**PLANNED UNIT DEVELOPMENT
STAFF REPORT****Date: July 15, 2004**

| <u>DEVELOPMENT NAME</u> | D'Iberville Town Homes |
| <u>CONTEMPLATED USE</u> | Multiple buildings on a single building site for a residential, condominium, town-home complex with private streets and shared parking. |

SITE PLAN

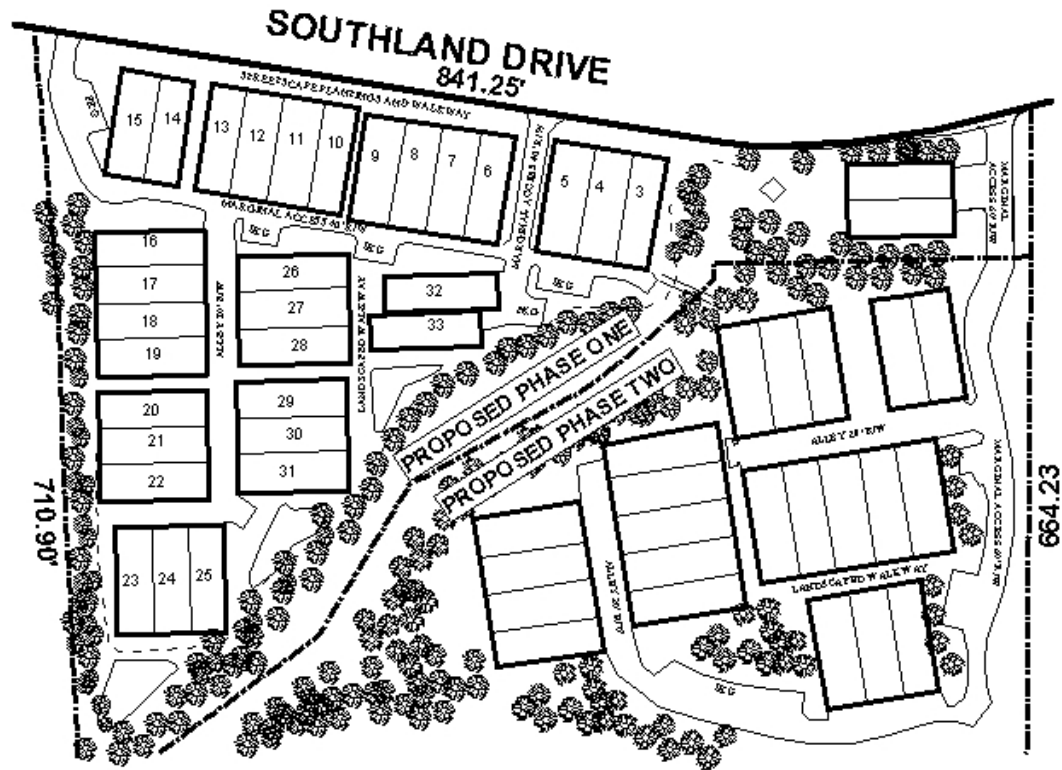
First, there is a note on the site plan stating that the individual units are to be sold and described as a single lot. In development meetings with the agent, the individual townhomes will be sold as a "unit" of Lot B, The Preserve Subdivision. This is essentially a condominium form of ownership that would be allowed with PUD approval and would not require subdivision approval—no new lots are being created, simply "units" of Lot B, The Preserve Subdivision are being sold. However, Lot B, The Preserve Subdivision, must be recorded prior to the issuance of any building permits for the site.

The second point of concern relates to traffic circulation. As illustrated on the site plan, the individual units will be served by either a marginal access road, which has a right-of-way of 40-feet; or alleys having 20-feet of right-of-way. Rights-of-ways would indicate that either the streets are to be constructed to city standards and accepted by the City for maintenance, or that private streets are proposed; either situation would require subdivision approval. This was explained to the agent; however, no subdivision application was submitted, and based upon extensive discussion with the agent, these "roads" and "alleys" are simply internal circulation drives similar to those serving other types of multi-family residential developments. Nevertheless, it should be noted that the minimum width needed for two-way traffic is 24-feet and additional width may be needed to comply with Traffic Engineering requirements.

The individual buildings will have between two and five units per building and in most instances there will be a common or service area between the buildings. The PUD Section of the Zoning Ordinance requires a minimum separation of 8 feet between two-story buildings and windows would not be allowed on the exterior walls flanking the common or service areas.

The applicant proposes a 20-foot setback along Southland Drive. The standard setback is 25-feet; however, the streetscape will contain a sidewalk, street plantings, lighting and benches, and the slightly reduced setback is more characteristic of the urban community setting the developer is proposing.

As with any new construction, full compliance with the landscaping and tree planting requirements of the Ordinance will be required. Additionally, the site contains wetlands and adjoins a creek, thus the area could be considered environmentally sensitive; therefore, the approval of all applicable federal, state and local agencies would be required. Moreover, as the site adjoins R-1, Single-Family Residential property to the South, the provision of a buffer in compliance with Section IV.D.1. should be provided.

Based upon the preceding, this application is recommended for approval subject to the following conditions: 1) that Lot B, The Preserve Subdivision be recorded prior to the issuance of any building permits for the site; 2) that the marginal access roads and alleys simply be developed as internal circulation drives and comply with the Zoning Ordinance (minimum width of 24-feet for two-way traffic) and Traffic Engineering requirements; 3) that a minimum separation of eight-feet be provided between two-story buildings and no windows allowed on the flanking walls; 4) full compliance with the landscaping and tree planting requirements of the Zoning Ordinance; 5) the approval of all applicable federal, state and local agencies; 6) the provision of a sidewalk, plantings, benches and lighting along Southland Drive as stating in the application; 7) the provision of a buffer, in compliance with Section IV.D.1. where the site adjoins R-1, Single-Family Residential zoning; and 8) full compliance with all municipal codes and ordinances.
